5.1 T220166 PA - 8 Souter Street, Beaconsfield VIC 3807 - Construction of Five Dwellings on a Lot

Executive Summary

APPLICATION NO.:	T220166
APPLICANT:	Simon Inglefinger (Newground Pty Ltd)
LAND:	L7 LP58426 V8463 F158, 8 Souter Street Beaconsfield VIC 3807
PROPOSAL:	Construction of Five (5) Dwellings on a Lot
PLANNING CONTROLS:	General Residential Zone – Schedule 1
NOTIFICATION & OBJECTIONS:	Pursuant to Section 52 of the <i>Planning and Environment Act 1987</i> , the application was advertised by the placing of signs on site and sending notices in the mail to nearby property owners. Five (5) objections were received.
KEY PLANNING CONSIDERATIONS:	Urban Design Streetscape Character Amenity Car Parking Traffic
RECOMMENDATION:	That Council Issue a Notice of Decision to Grant a Planning Permit, subject to the conditions within this report.

Figure 2: Proposed Ground Floor Plan

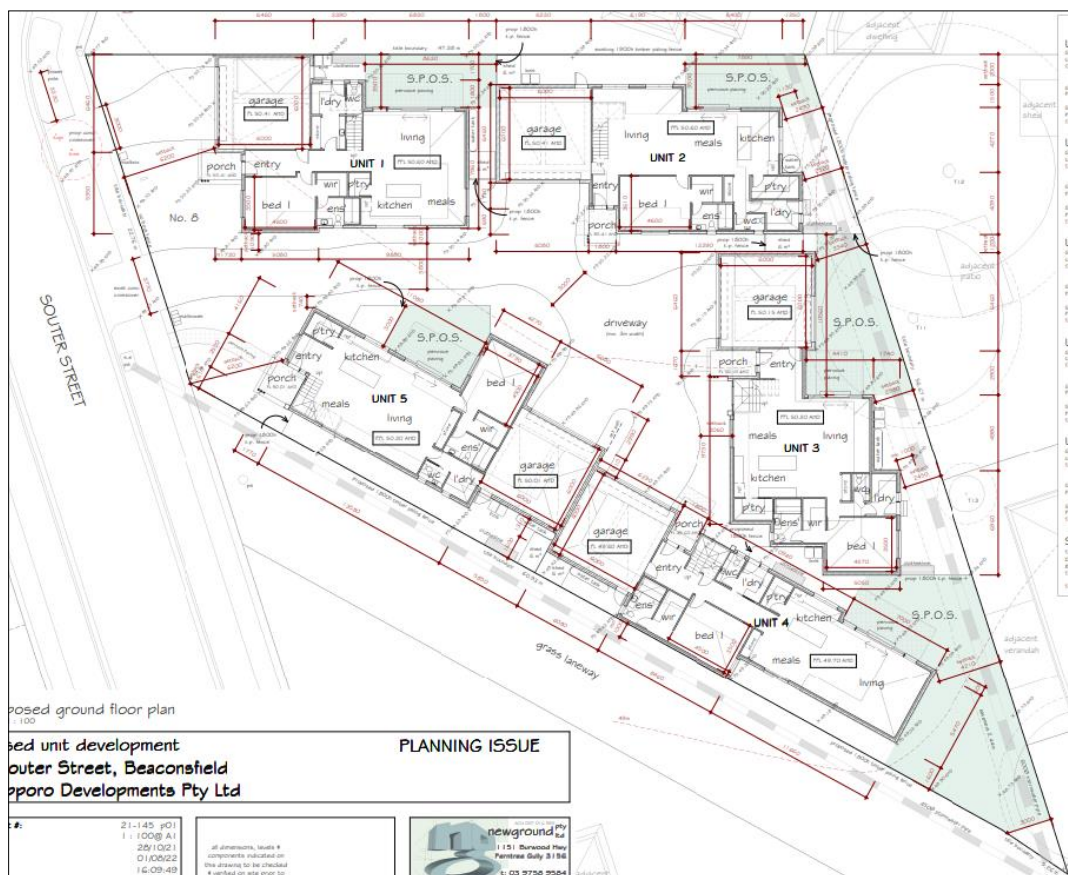
- a) The existing 'No Stopping Sign' conflicting with the proposed crossover, to be relocated to the north of the proposed crossover, ensuring the sign pole has a clearance of 1 m to the proposed crossover.

In addition to the above, the application has also been referred to Councils Traffic & Transport Services Department who have reviewed the proposal and raised no concerns with the proposals impact on local road network and ultimately provided a recommendation of support, subject to conditions relating to the construction of the proposed crossover and relocation of existing street signage.

typical window screen / overlooking diagram
scale 1 : 20

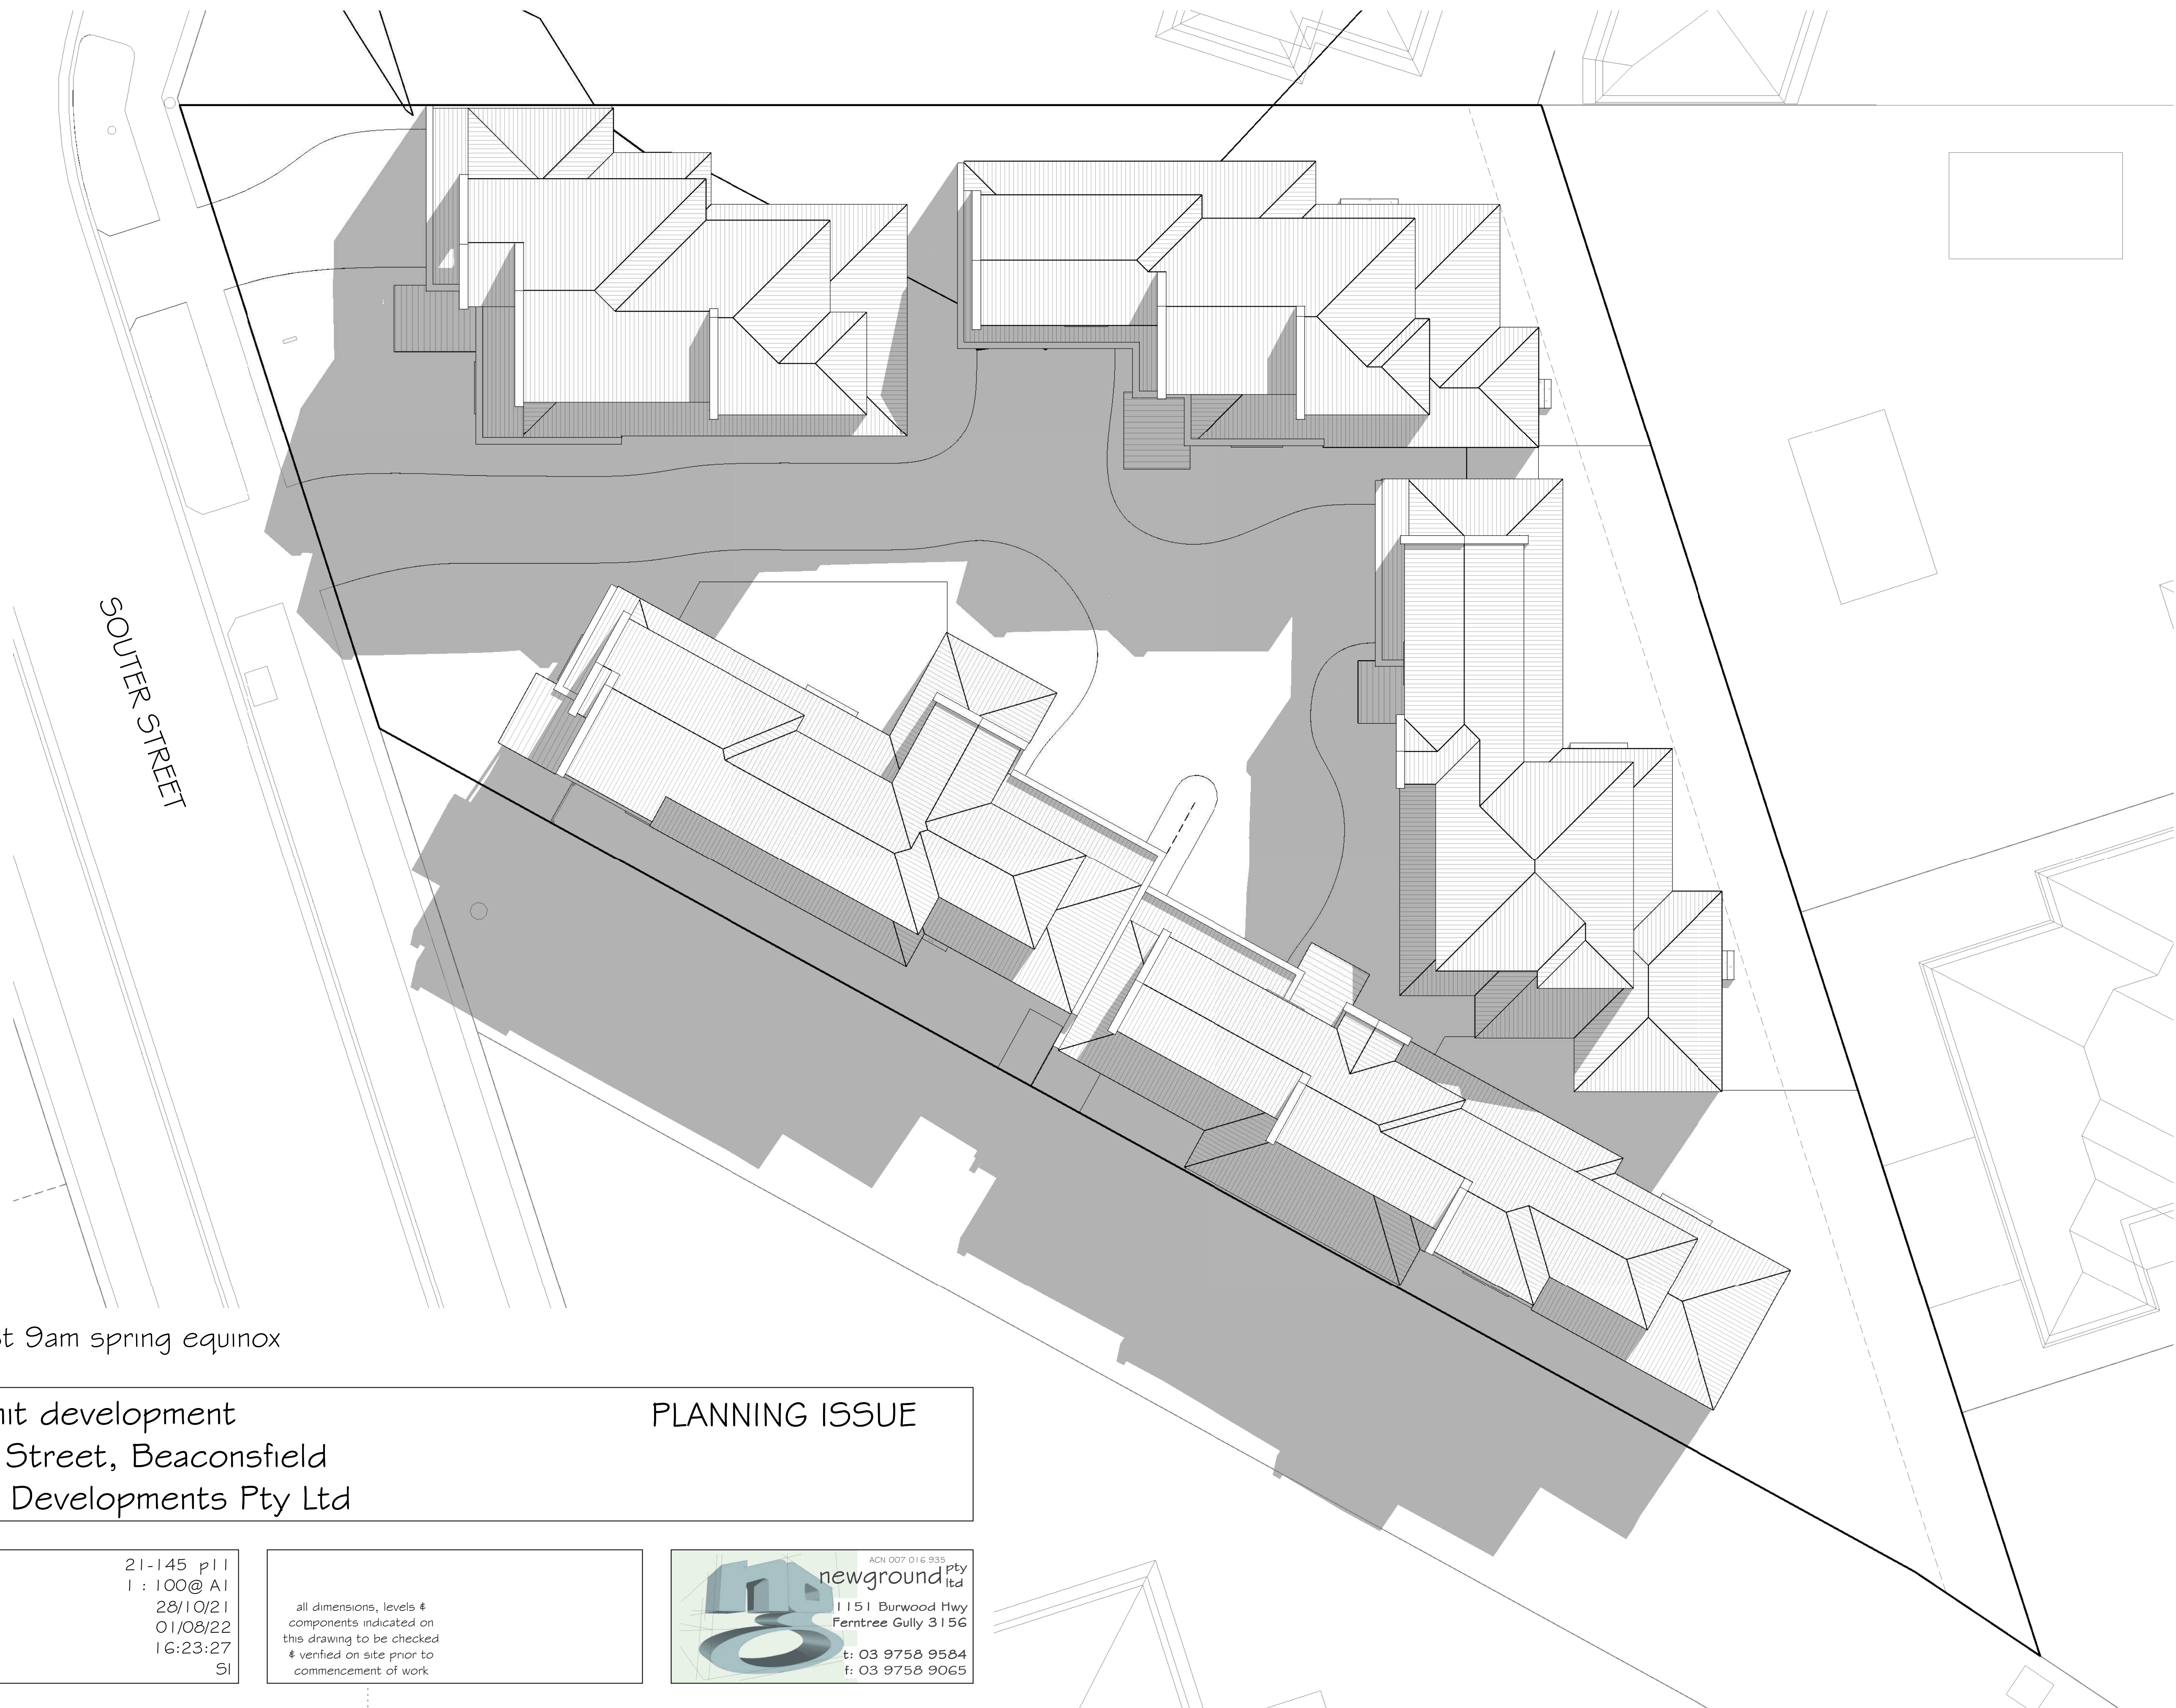
- b) Details of proposed screening to of first floor habitable windows in accordance with Clause 55.04-6 (Standard B22) of the Cardinia Planning Scheme.

STANDARD B22: OVERLOOKING Limit views into existing secluded private open space and habitable room windows.	<ul style="list-style-type: none"> A habitable room window, balcony, etc. should be located and designed to avoid direct views into the secluded private open space and habitable room windows of an existing dwelling within 9 metres. 	✓Satisfactory The application proposes the provisions of screens for all first-floor habitable room windows which have view lines into neighbouring properties. A condition will be placed on permit to ensure that screening is compliant with required standards.

shadows cast 9am spring equinox
scale 1 : 100

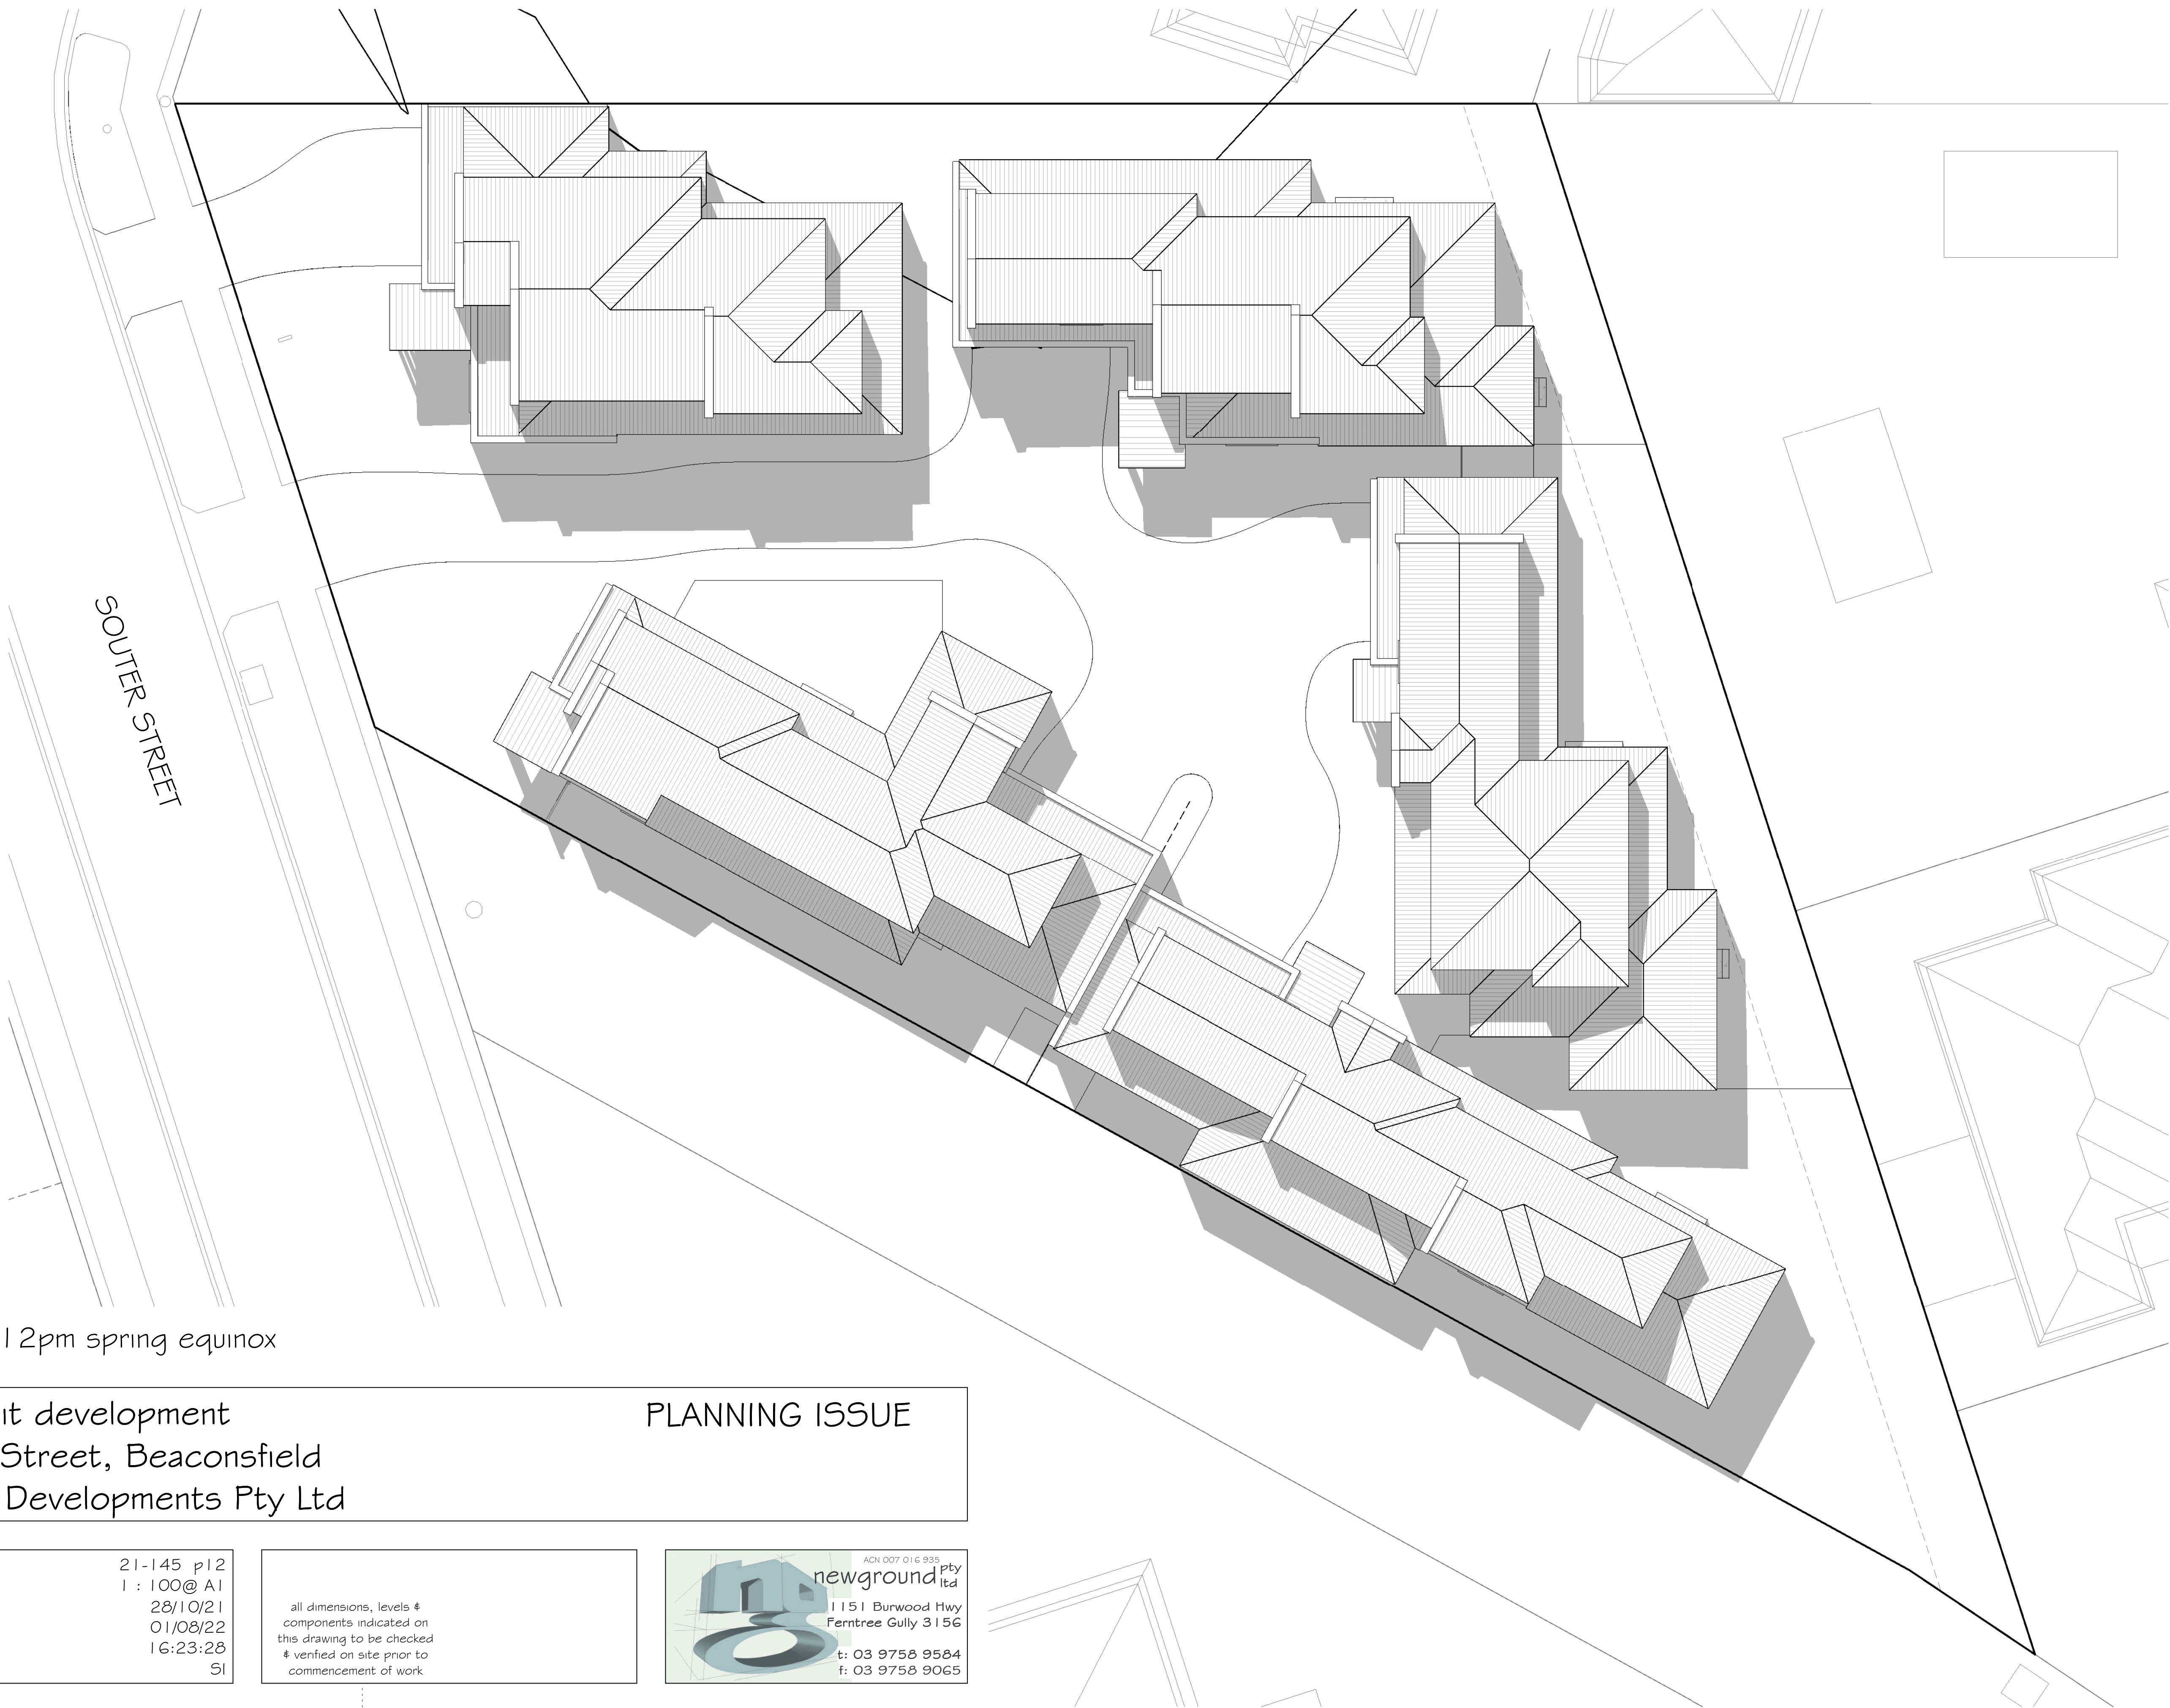
- c) Demonstrated compliance with Clause 55.04-5 (Standard B21 – Overshadowing open space) of the Cardinia Planning Scheme.
2. The layout of the buildings and works, as shown on the endorsed plans, must not be altered or modified without the consent in writing of the Responsible Authority.

STANDARD B20: NORTH-FACING WINDOWS Allow adequate solar access to existing north-facing habitable room windows	<ul style="list-style-type: none"> If a north-facing habitable room window of an existing dwelling is within 3 metres of a boundary on an abutting lot, a building should be setback from the boundary 1 metre, plus 0.6 metre for every metre of height over 3.6 metres up to 6.9 metres, plus 1 metre for every metre of height over 6.9 metres, for a distance of 3 metres from the edge of each side of the window. 	N/A - No such windows are located adjoining the development site.
STANDARD B21: OVERSHADOWING OPEN SPACE Ensure buildings do not significantly overshadow existing secluded private open space	<ul style="list-style-type: none"> Where sunlight to the secluded private open space of an existing dwelling is reduced, at least 75%, or 40 square metres with minimum dimension of 3 metres, whichever is the lesser area, of the secluded private open space should receive a minimum of 5 hours of sunlight between 9 am and 3 pm on 22 September. 	✓Satisfactory Overshadowing is to occur to the property to the east, however this overshadowing is to occur in afternoon hours only. Conditions will be placed on any permit issued to ensure appropriate overshadowing diagrams will be provided identifying compliance with this standard.
